**ADDENDUM
NO. 2**

November 3, 2022

**LIBERTY ELEMENTARY SCHOOL RENOVATIONS
Chesterton, IN 46304**

This Addendum consists of Pages ADD 2-1 through ADD 2-3 and attached Addendum No. 2 from Gibraltar Design dated November 2, 2022 and consisting of 7 pages, Specification Section 08 33 00 - Rolling Doors and Grilles, and 41 Drawings.

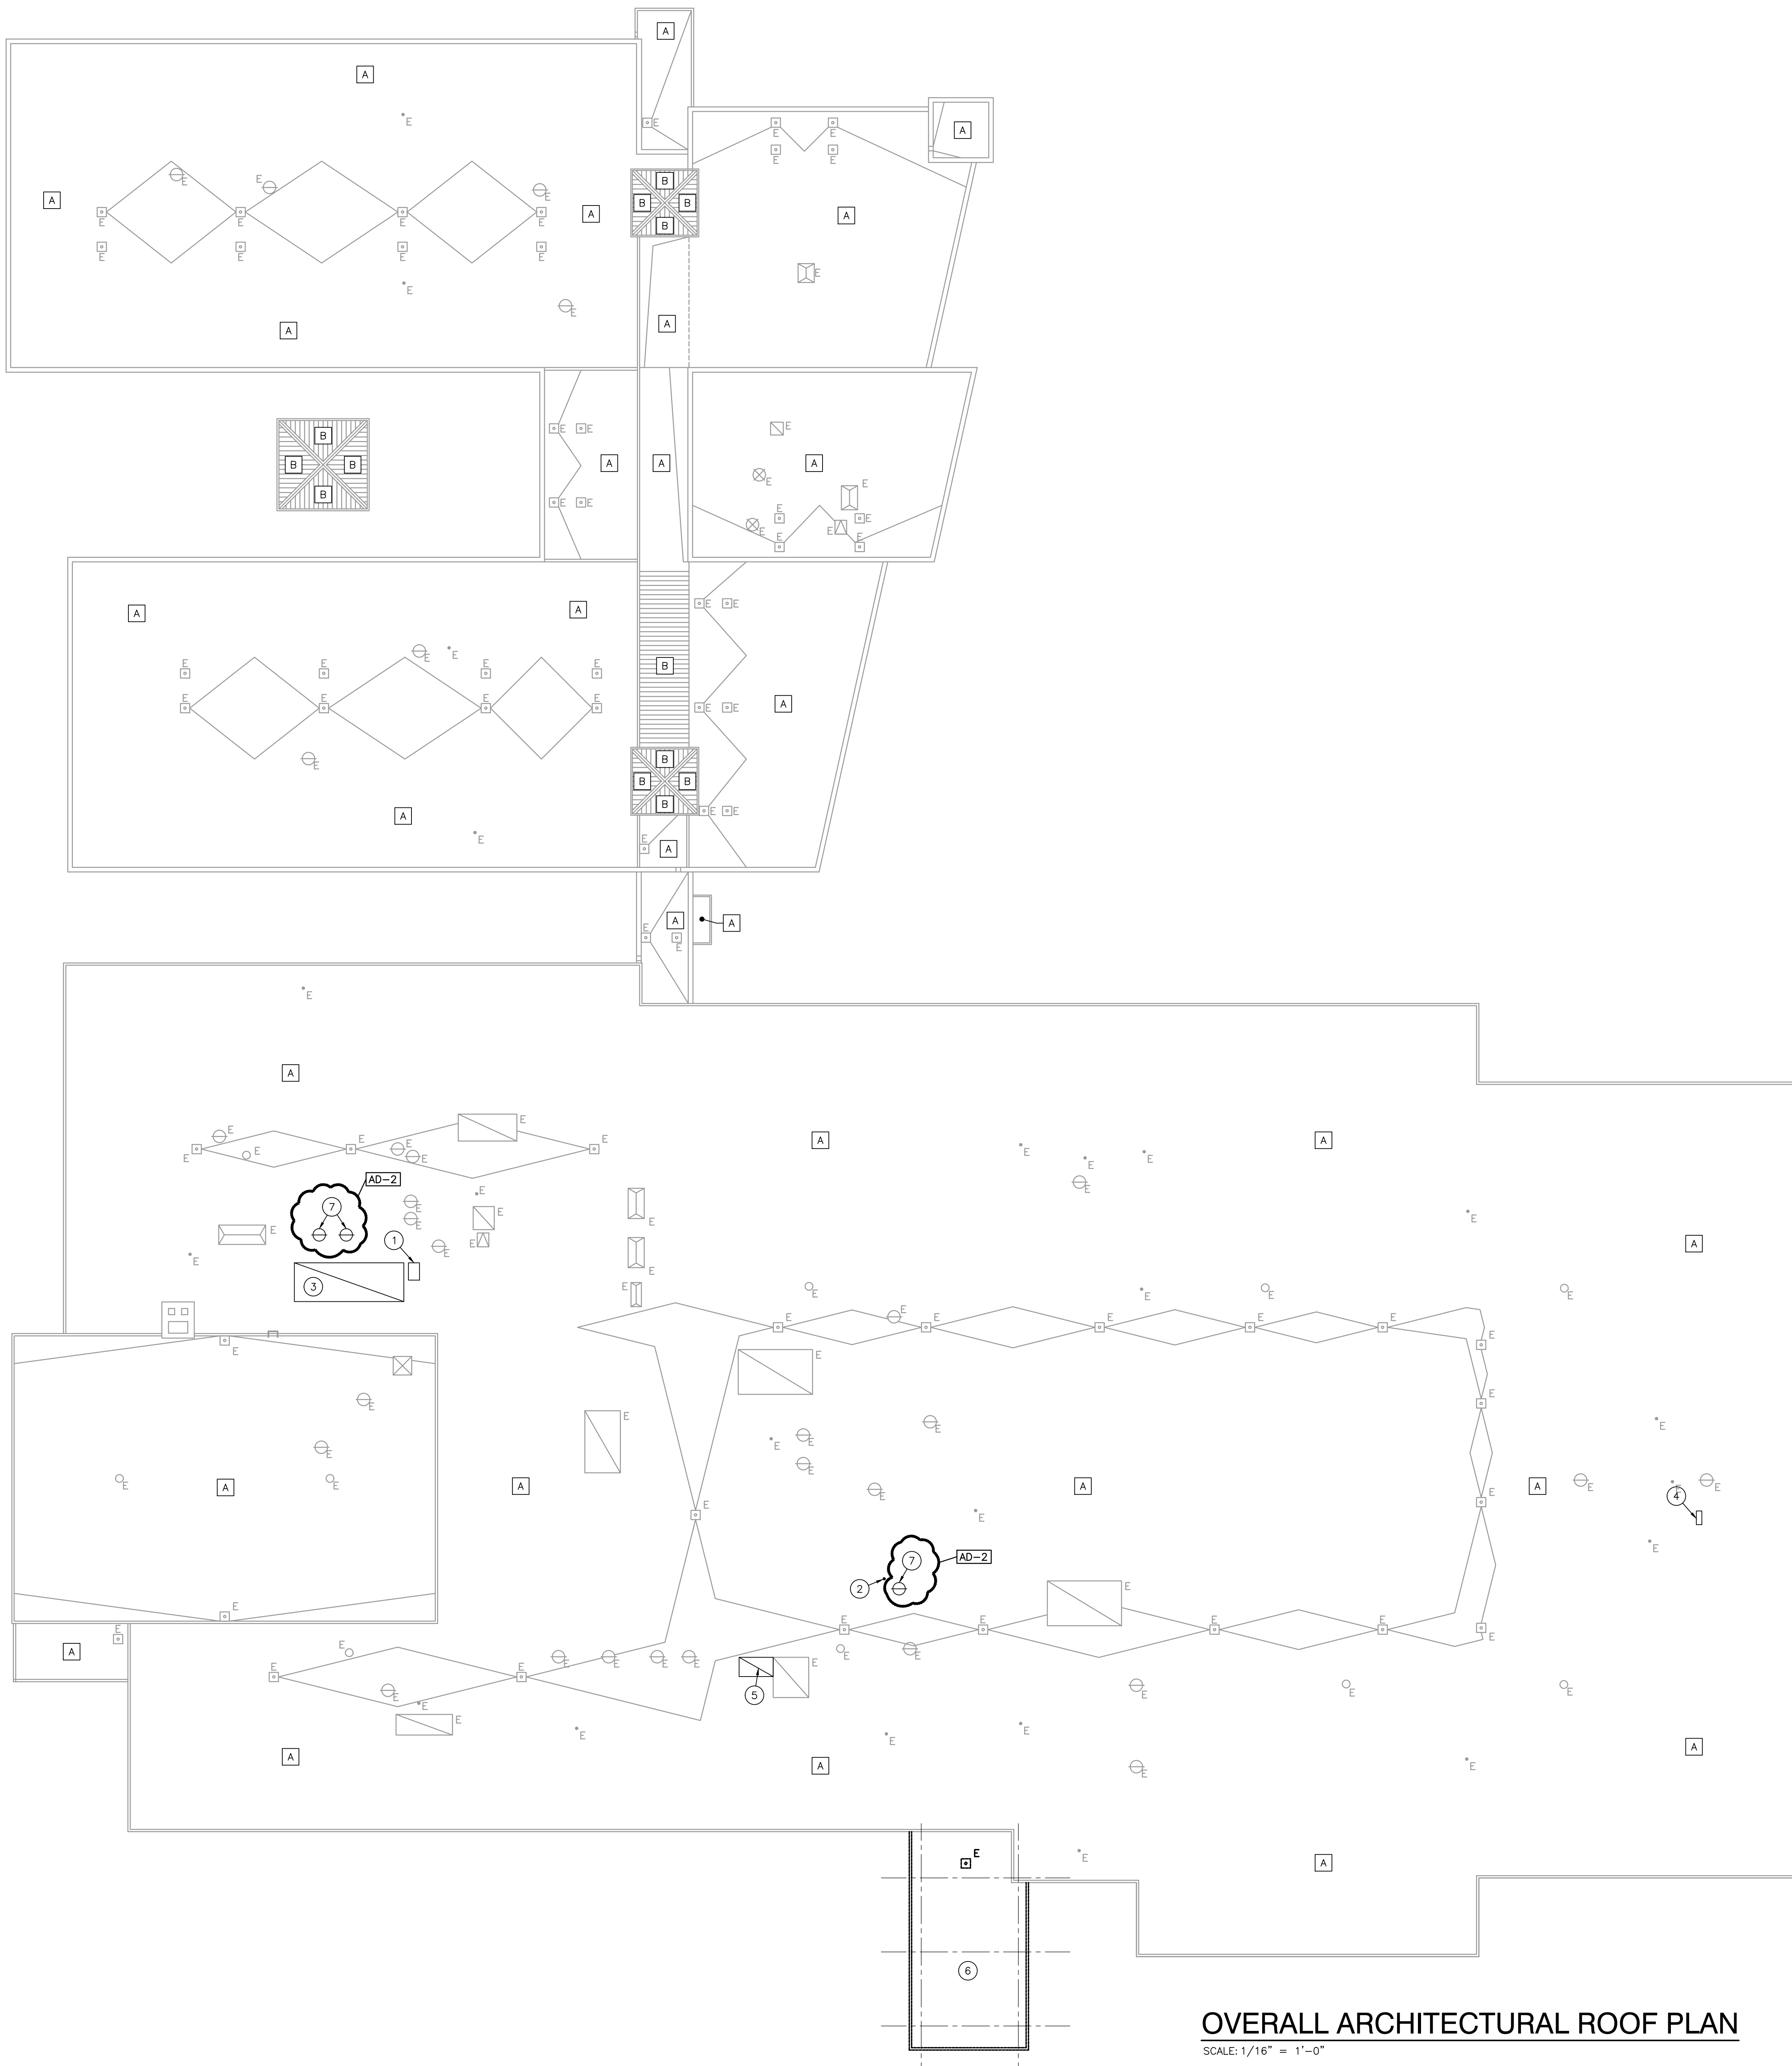
14. Sheet A-201

- A. Refer to revised full size drawings, included in this Addendum, for the following revisions:
1. Added Roof Plan Note 7
 2. Added three (3) exhaust fan locations to coordinate with Mechanical drawings.

© GIBRALTAR DESIGN SHEET
A-301

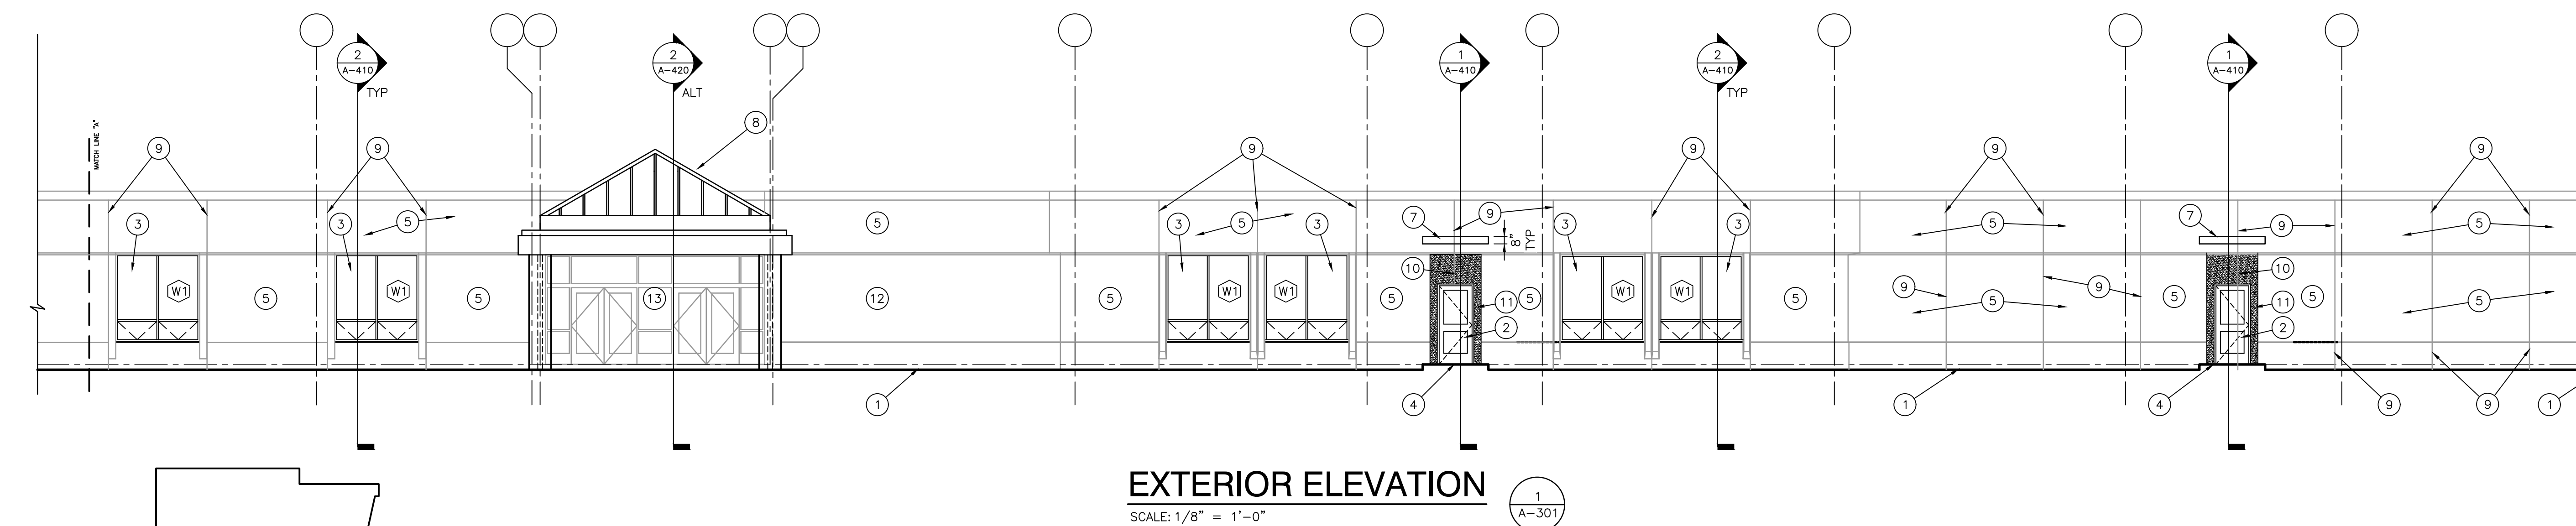
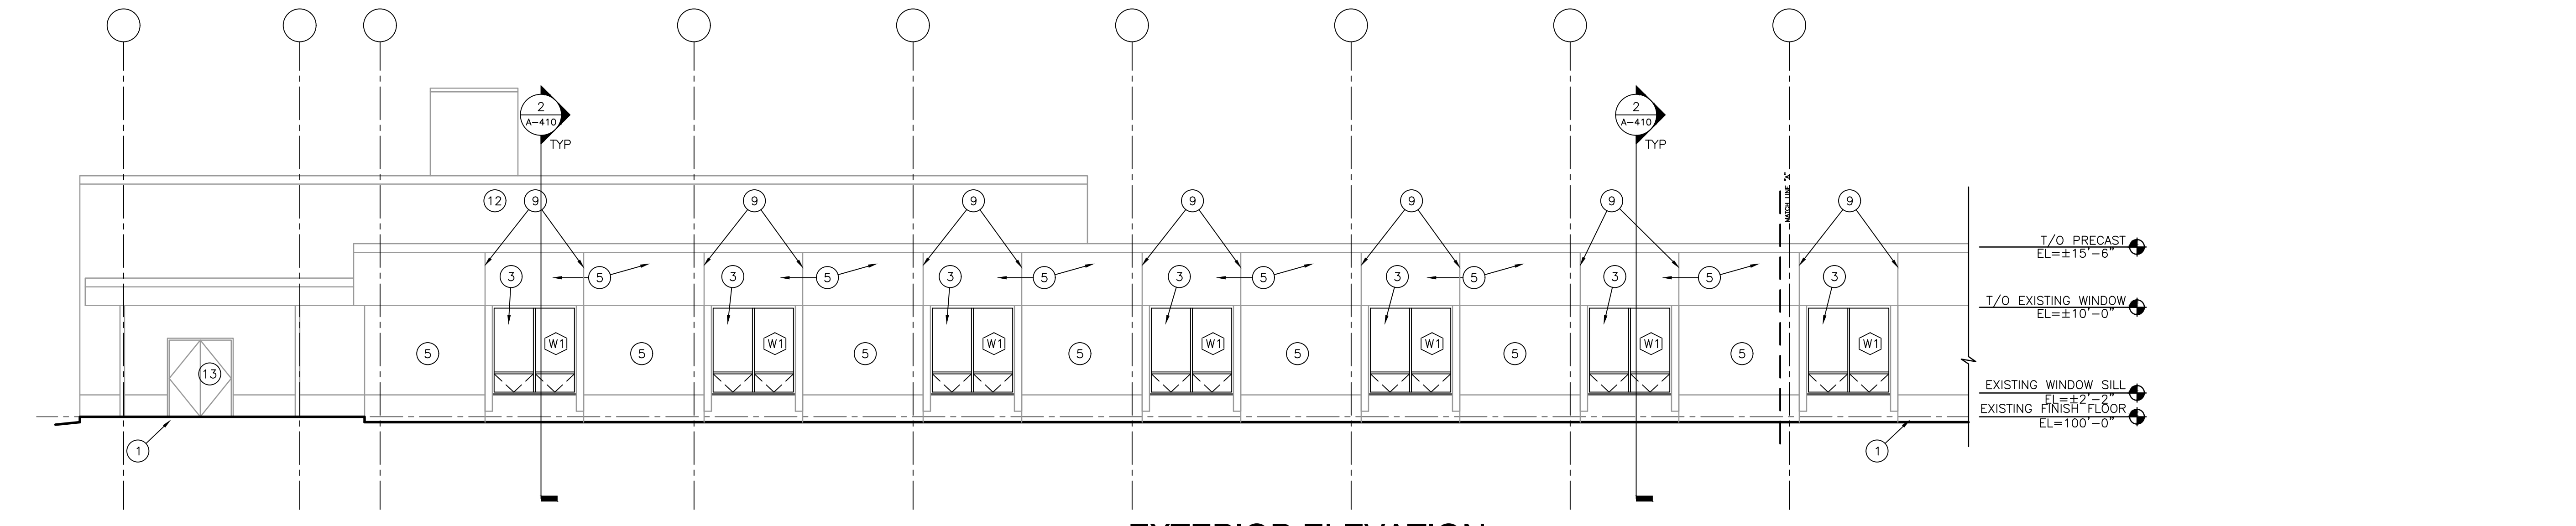
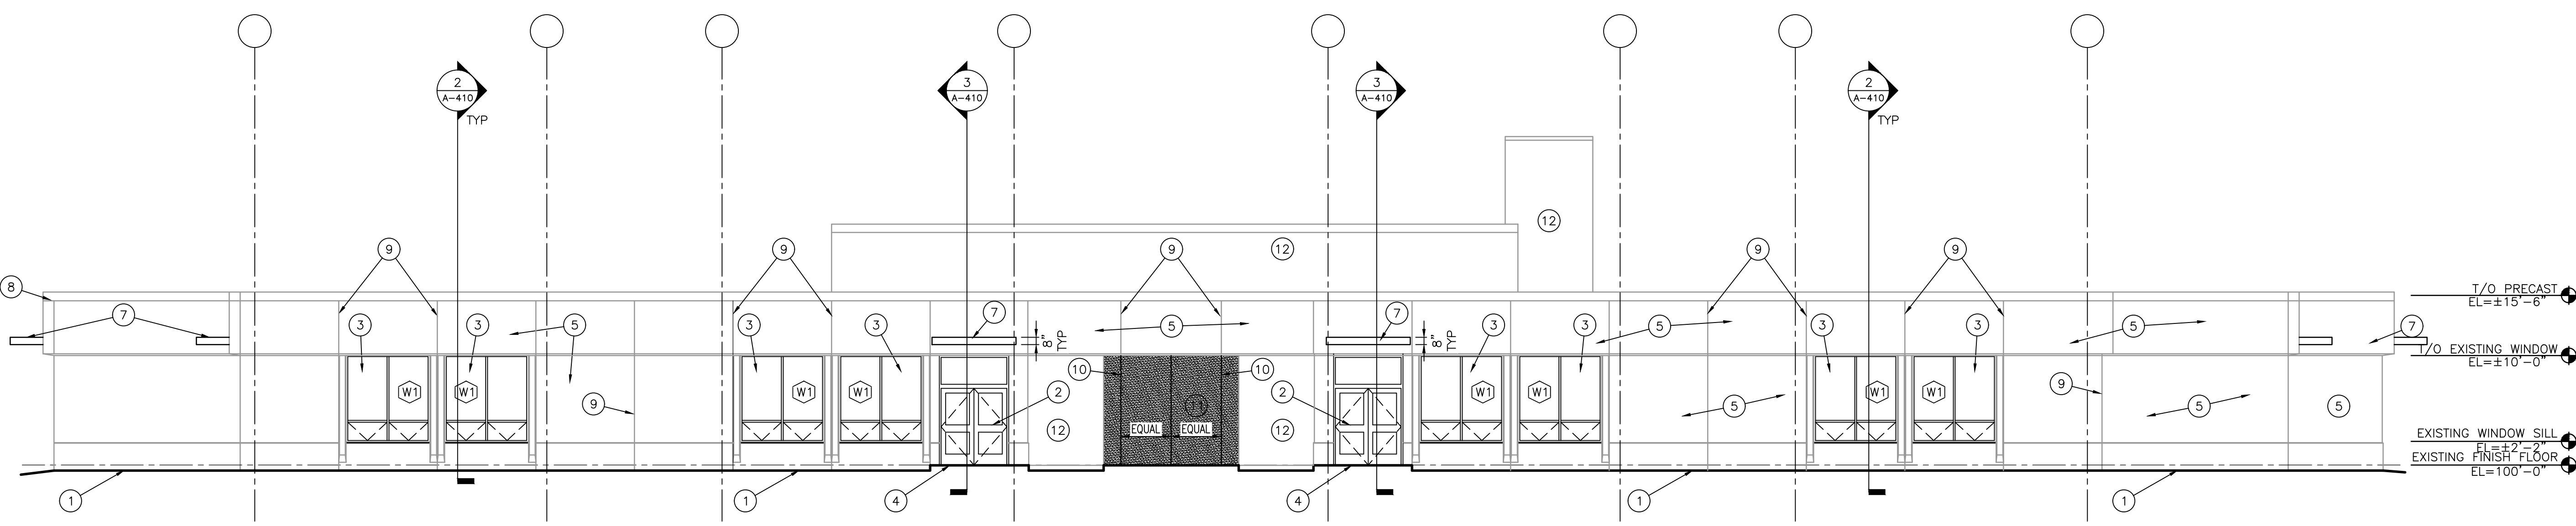
- A. Refer to three (3) revised full size drawings, included in this Addendum, for the following revisions:
1. Remove General Elevation Notes H and I directing contractor to remove and replace sealant at existing vertical control joints and at perimeter of existing windows.
